**ENVIRONMENTAL PROTECTION AGENCY****40 CFR PART 52**

**Final Response to Petition From New Jersey Regarding SO<sub>2</sub> Emissions From the Portland Generating Station****AGENCY:** Environmental Protection Agency (EPA).**ACTION:** Final rule.

**SUMMARY:** The EPA is making a finding that the coal-fired Portland Generating Station (Portland), owned and operated by GenOn REMA LLC (GenOn), in Upper Mount Bethel Township, Northampton County, Pennsylvania, is emitting air pollutants in violation of the interstate transport provisions of the Clean Air Act (CAA or Act). Specifically, the EPA finds that emissions of sulfur dioxide (SO<sub>2</sub>) from Portland significantly contribute to nonattainment and interfere with maintenance of the 1-hour SO<sub>2</sub> national ambient air quality standard (NAAQS) in New Jersey. This finding is made in response to a petition submitted by the State of New Jersey Department of Environmental Protection (NJDEP) on September 17, 2010. In this action, the EPA is establishing emission limitations and compliance schedules to ensure that Portland will eliminate its significant contribution to nonattainment and interference with maintenance of the 1-ho

**Figure VI.C-1. Comparison of 2010 Emissions from Portland Units 1 and 2 with Allowable Emissions and Different Levels of Reduction from Allowable Emissions.**

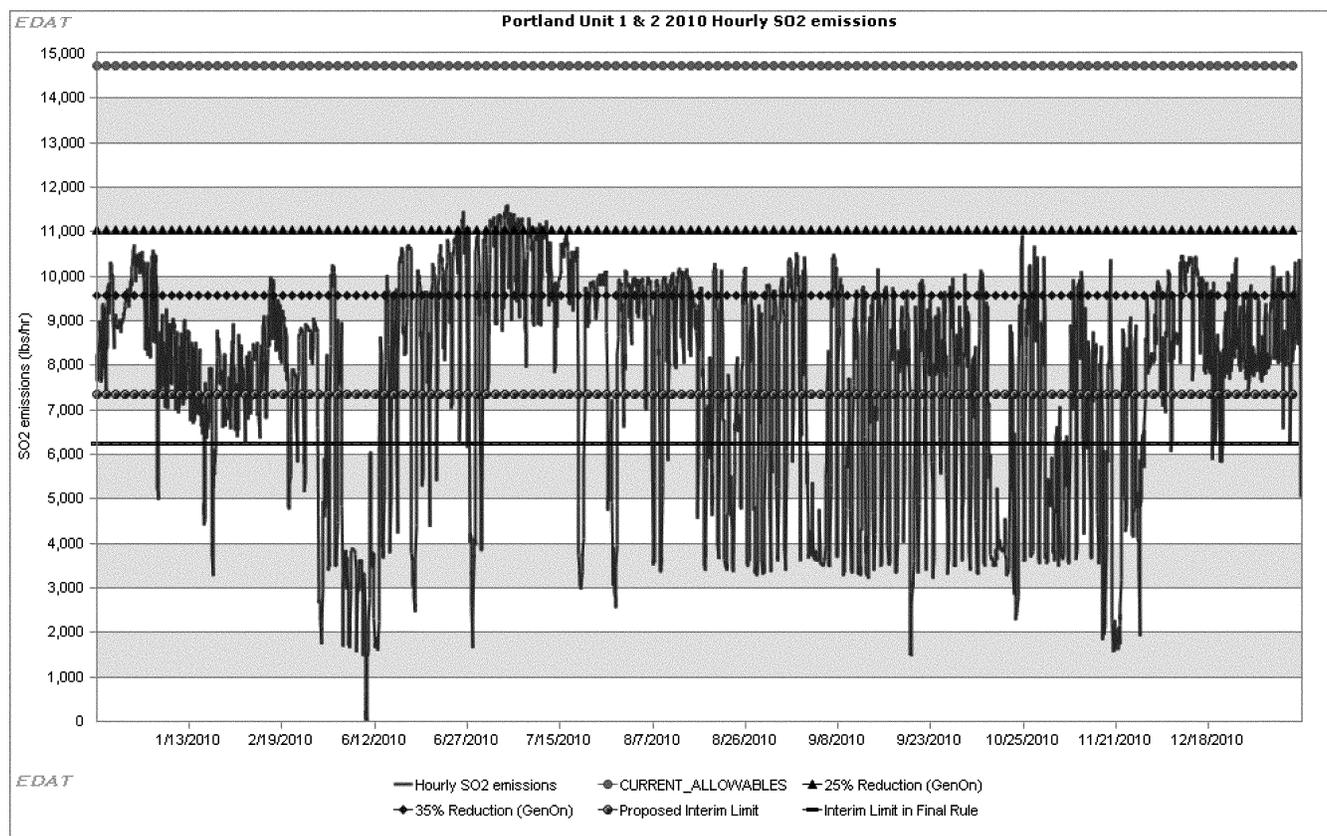
*Comment:* Based on the results of the test burn report, GenOn concluded that (1) Sustained unit operations using a blend of Northern and Central Appalachia coals sufficient to achieve a 25 percent reduction in allowable SO<sub>2</sub> emissions is achievable with a modest investment and an implementation schedule of 6 months, and (2) sustained unit operations using a blend of Northern and Central Appalachia coals to achieve a 35 percent reduction in allowable SO<sub>2</sub> emissions should be achievable with additional investments and an implementation schedule of 8 to 12 months after GenOn has established an operational record and completed equipment performance evaluations at the 25 percent reduction blend level, and any necessary permits are acquired.

*Response:* The EPA evaluated the suggested interim reductions in the GenOn test burn report. The EPA concluded that based upon this evaluation, these targets are significant underestimates of the readily available interim emissions reductions, represent very minimal reductions from current operations, and are inconsistent with the results of the test burn.

Figure VI.C-1 shows the hourly SO<sub>2</sub> emissions for all of 2010 at Portland, shown as the sum of emissions from units 1 and 2. For the EPA (and GenOn's) air quality analysis, the assumed allowable emissions rates for units 1 and 2 were 5,820 lb/hr and 8,900 lb/hr, respectively, resulting in a total allowable rate of 14,720 lb/hour. A 25

percent reduction from this amount, that is a 25 percent reduction from current allowable, thus becomes 11,040 lb/hr. As shown in Figure VI.C-1, during 2010, Portland's hourly emissions exceeded 75 percent of

allowable emissions only rarely. Accordingly, a 25 percent reduction in allowable emissions effectively represents status quo operations. A 35 percent reduction in allowable emissions, or 9,568 lb/hr, would require

at most a roughly 15 percent reduction in current emissions. EPA continues to believe that the facility can make much more significant reductions in line with the final interim limits within a year.
